## **PROJECT NARRATIVE FOR CMPA MINOR PERMIT AUTHORIZATION FOR CABIN BLUFF HAUL OUT SLIP:**

**From:** Scott Farrell <sfarrell@farrellmarine.com>  
**Sent:** Friday, January 27, 2017 6:21 PM  
**To:** Stockel, Skye  
**Cc:** Scott Farrell  
**Subject:** RE: Cabin Bluff Boat Basin  
**Attachments:** CMPA Narratives - FBMC - 012717.docx

PROJECT  
Cabin Bluff Sheet Pile Wall

TITLE SECTION

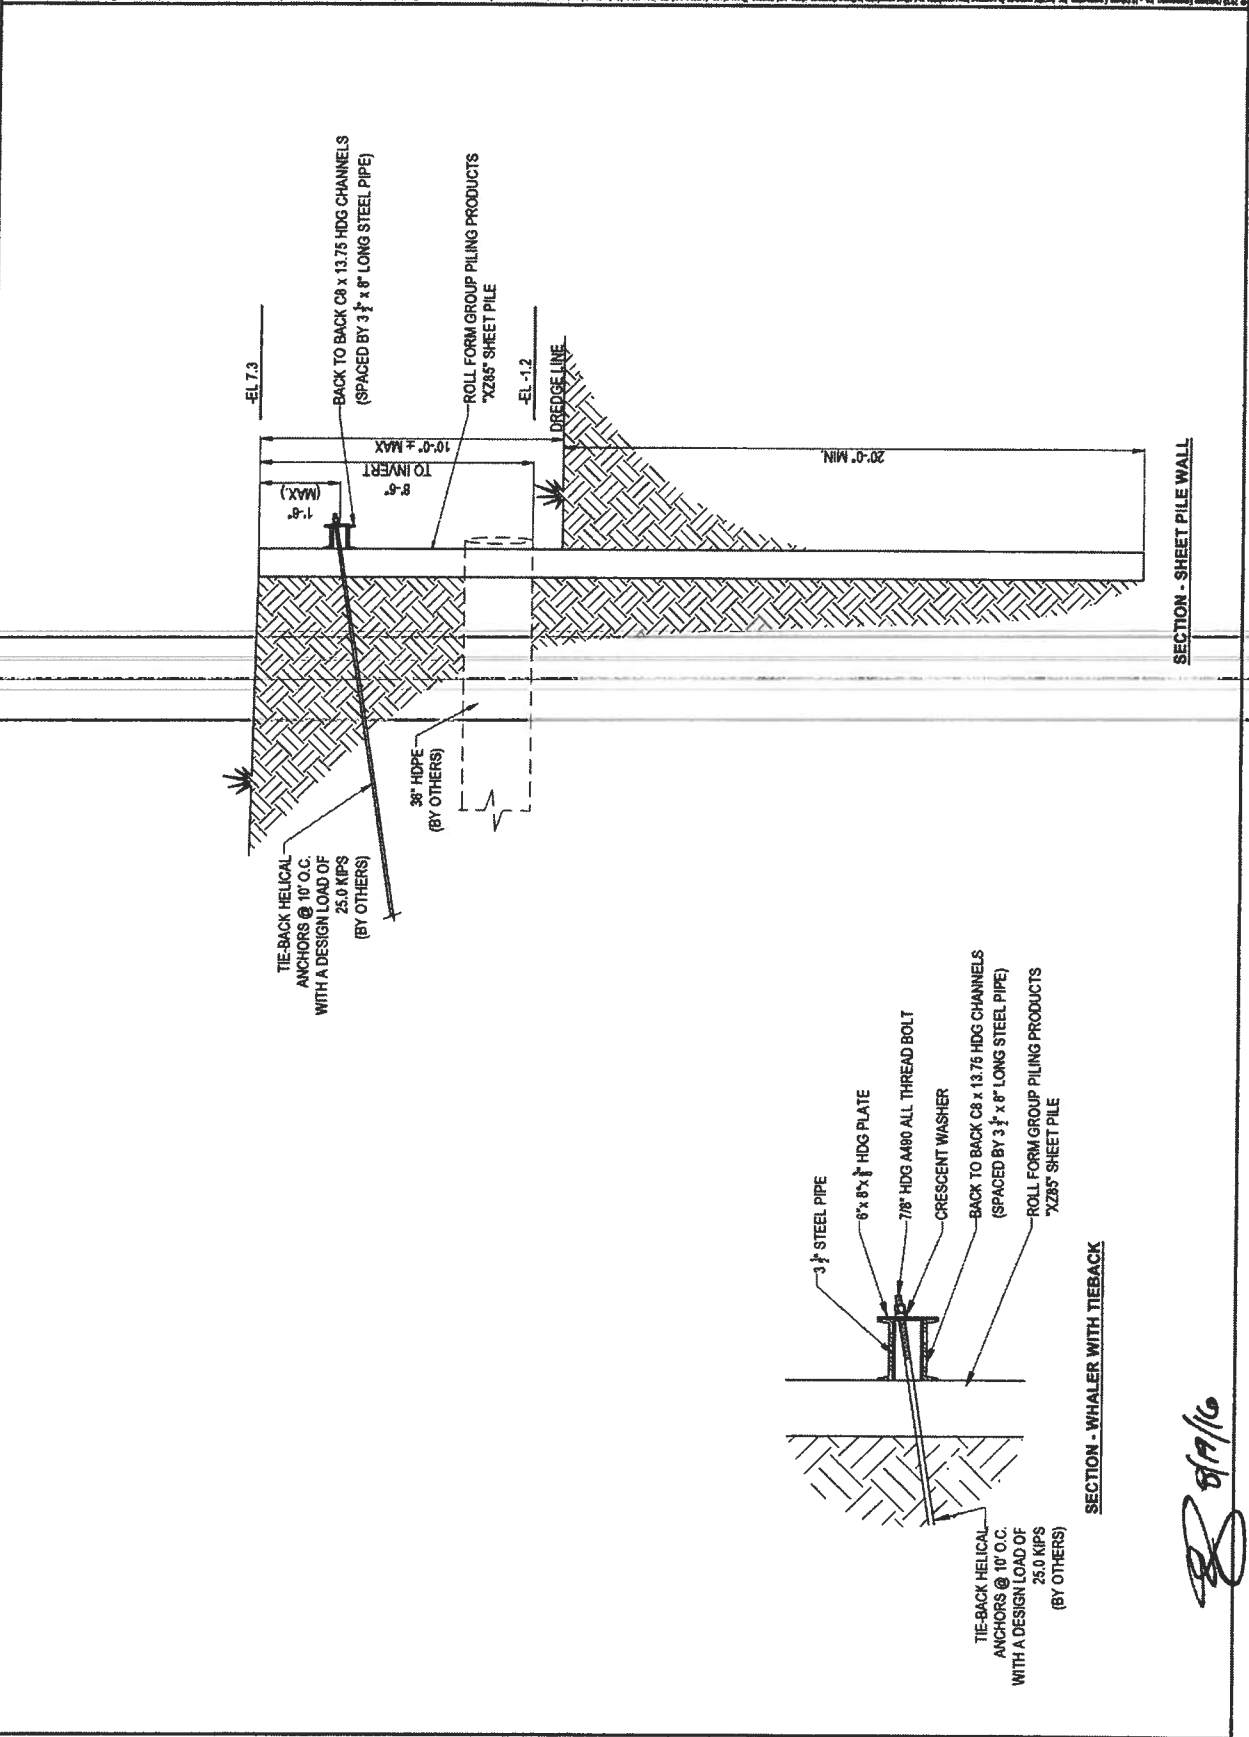
- All measurements have been changed to 231’
- I still need the height and width of the existing and proposed bulkheads to be defined. This helps the Department calculate total square footage for comparison with the application materials. There is a profile included with the materials submitted but that is for the most landward portion of the basin where the culvert will be. It doesn’t include the width of the proposed bulkhead or extension of the culvert into the basin. Also, one would expect the height from the top of the bulkhead to the mud line to be different closer to the mouth of the basin.

- Height is relatively uniform in the entire basin because the river bottom is relatively uniform in the basin. The height is 10’. I am not sure what you would like for the “width” of the existing and proposed bulkhead? It is stated in the narrative that the new sheet pile will be approx. 2’ from the existing. Do you mean the corrugation depth (profile depth) of the sheet pile? If so, it would be considered a net zero for square square footage as the corrugations are symmetric. However, if you need the profile depth, we can get this but it can be confusing to show on a drawing.
